NOTICE OF DECISION

TENTATIVE PARTITION PLAN / CLASS 2 ADJUSTMENT CASE NO.: PAR-ADJ24-11

NOTICE OF DECISION DATE: October 7, 2024

SUMMARY: A partition of a property into a three parcel flag lot.

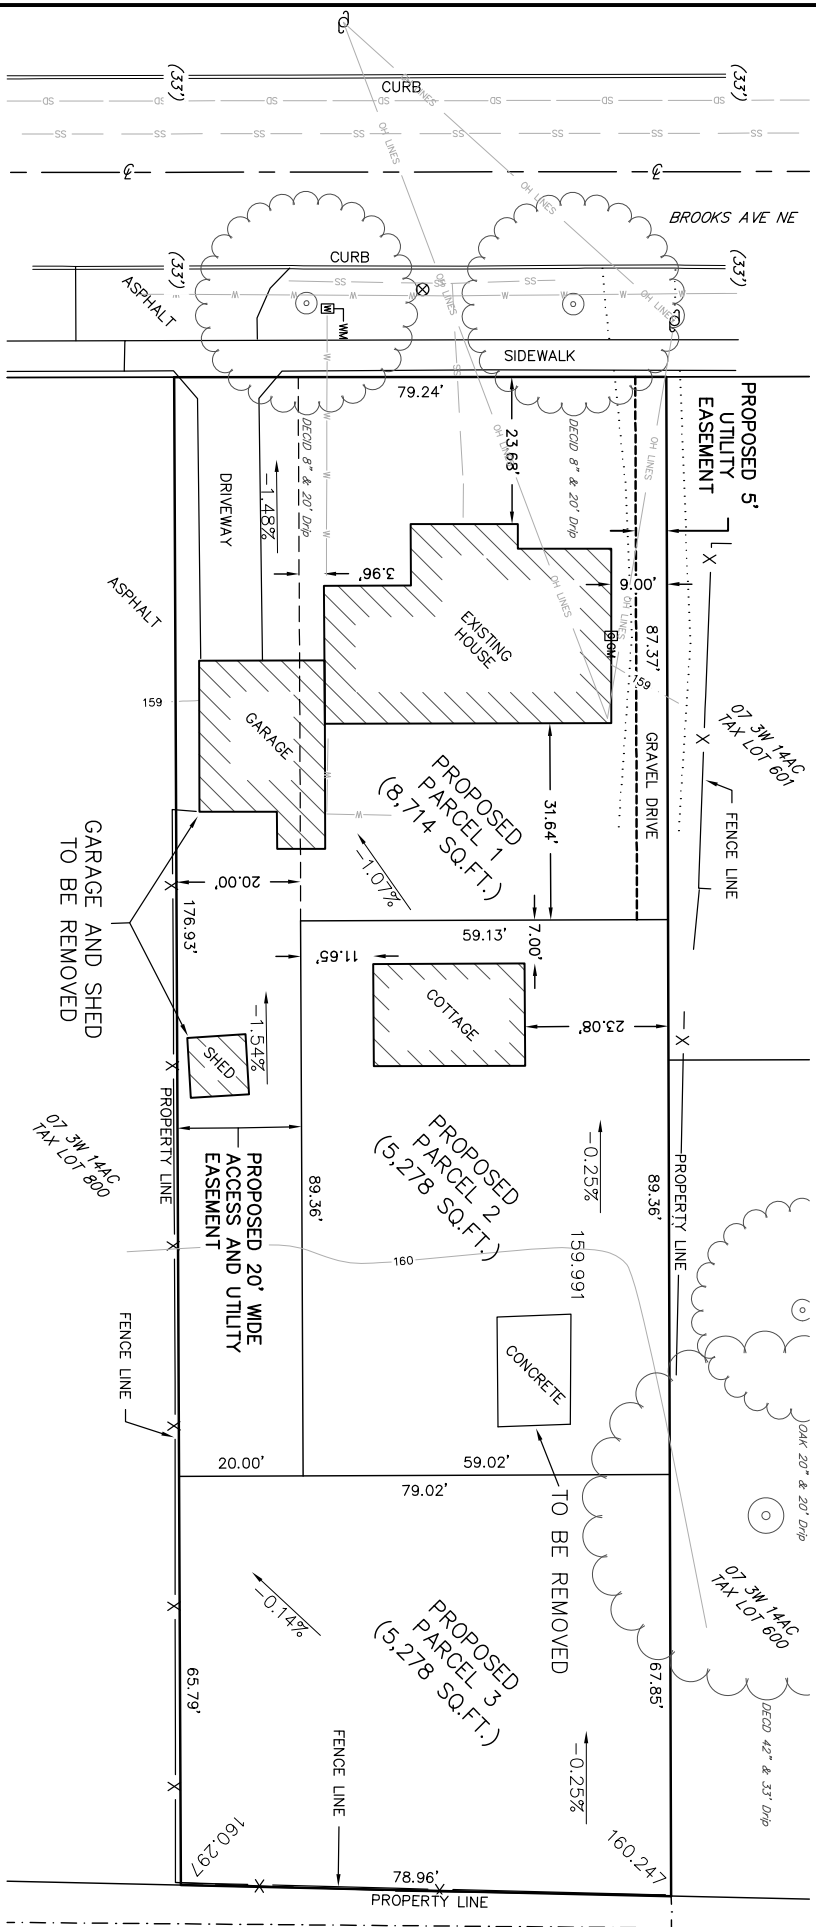
Finding: As shown on the tentative partition plan (**Attachment B**), proposed Parcel 1 is 5,168 square feet, exclusive of the accessway, and would have 59 feet of frontage on Brooks Ave NE. The proposed parcel is 59 feet in width, exclusive of the accessway, and 87 feet in depth. Parcel 1 meets the area, width, depth, and frontage lot standards. Proposed Parcel 2 will be an infill flag lot 5,278 square feet in size with 59 feet of width and 89 feet of depth and will have access to Brooks Ave NE via the flag lot accessway. Proposed Parcel 3 will be an infill flag lot 5,278 square feet in size with 59 feet of width and 89 feet of depth and will have access to Brooks Ave NE via the flag lot accessway. Proposed Parcels 2 and 3 do not meet the minimum 5,500 square foot area required of an infill flag lot. To ensure the parcels meet the minimum area, the following condition shall apply.

The plans also indicate there is an existing “cottage” on proposed Parcel 2, which is classified as an accessory structure. By definition, an accessory use cannot be permitted without a primary use on the property; therefore, in order to create the parcel, the accessory structure shall be removed or obtain the necessary permits to convert it to a standalone dwelling on the new parcel. To ensure the proposed partition plan meets the development standards of the RS zone, the following condition shall apply.

Finding: The tentative plan indicates the proposed flag lot accessway will be 177 feet in length by 20 feet in width, which, per Table 800-1, could serve a maximum of two dwelling units. With the existing dwelling on proposed Parcel 1, the flag lot accessway will serve three parcels and up to four units. The proposed accessway length is more than the maximum 150 feet length allowed and less than the minimum 25 feet in width to serve three to four units between the three parcels. Due to the location of the existing house and the infeasibility of providing a wider and longer accessway, the applicant has requested a Class 2 Adjustment to this standard, addressed in Section 9 below. To ensure the flag lot accessway can serve the three parcels and up to three-to-four units, the following condition shall apply.

The applicant's plan indicates the attached garage of the existing dwelling of Parcel 1 will be removed to accommodate the flag lot accessway. With the removal of the garage, the plans indicate the existing house will have a minimum setback of four feet from the proposed 20-foot-wide accessway. Due to the existing house and required setback, the accessway cannot be further widened without further alterations to the house. As proposed, the 20-foot accessway could only serve two units, limiting its access for proposed Parcels 2 and 3 only. Given the length of the existing lot at 242 feet, an accessway with a minimum 20-foot width and maximum 150-foot length would only allow for one exceptionally large lot in the rear of the property.

Condition 1: Prior to final plat, the applicant shall revise the proposed partition plan to ensure proposed Parcel 2 and Parcel 3 meet the minimum lot standards of SRC 511.010, Table 511-2.

Condition 3: Prior to final plat approval, obtain a demolition permit to remove the existing accessory structure on proposed Parcel 2 or obtain the required building permits to establish it as a standalone dwelling.

Condition 4: Prior to final plat, if the accessory building on Parcel 2 is to remain, the applicant shall revise the proposed plat to ensure the building meet the minimum setback standards of SRC 511.010, Table 511-3.
